# Access Compliance Report

## Public Rights-of-Way

### (Curb Ramps)

Intersection ID: 46203	Main Street: LOROPETALUM_RD	Cross Street: IMPATIEN_DR	Location: SE
ADA ID: 6781131E0873	Ramp Type: PerpDiag	Initial Pass/Fail: Fail	Overall Compliance: No
Severity Score: 8.75			
Codes/Mitigation Info/Possible Solution		Field Measurements/Component Compliance

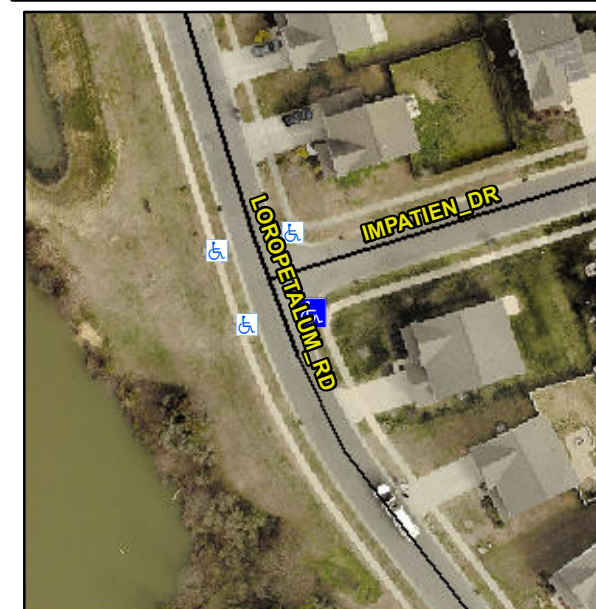
**Not Found, R304.5.1**

Compliance	Description	Data	Compliance	Description	Data
N/A	Ramp Length (in)	70.0	Yes	Ramp Slope (%)	6.9
No	Ramp Width (in)	47.0	Yes	Ramp XSlope (%)	1.3
N/A	Flare Type LT	N/A	N/A	Flare Type RT	N/A
N/A	Flare Slope LT (%)	N/A	N/A	Flare Slope RT (%)	N/A
N/A	Flare Traversable LT?	N/A	N/A	Flare Traversable RT?	N/A
N/A	Landing Length (in)	N/A	N/A	DWS Provided?	N/A
N/A	Landing Width (in)	N/A	N/A	DWS Contrast?	N/A
N/A	Landing Slope (%)	N/A	N/A	DWS Length (in)	N/A
N/A	Landing X Slope (%)	N/A	N/A	DWS Full Width?	N/A
N/A	Landing Curb? (Y/N)	N/A	N/A	DWS Offset (in)	N/A
N/A	Shared Landing?	N/A			
N/A	Gutter Ponding?	N/A	N/A	Gutter Slope (%)	N/A
N/A	Gutter Lip Ht (in)	1.0	N/A	Gutter X Slope (%)	N/A
N/A	Painted X Walk1?	No	N/A	Painted X Walk2?	No
	X Walk 1 Direction	To N		X Walk 2 Direction	To W
N/A	X Walk 1 Width (in)	N/A	N/A	X Walk 2 Width (in)	N/A
	X Walk 1 Slope (%)	0.4		X Walk 2 Slope (%)	1.9
	X Walk 1 X Slope (%)	0.3		X Walk 2 X Slope (%)	0.7

**Remove & Replace Curb Ramp With Two New Directional Ramps or Equivalent.**
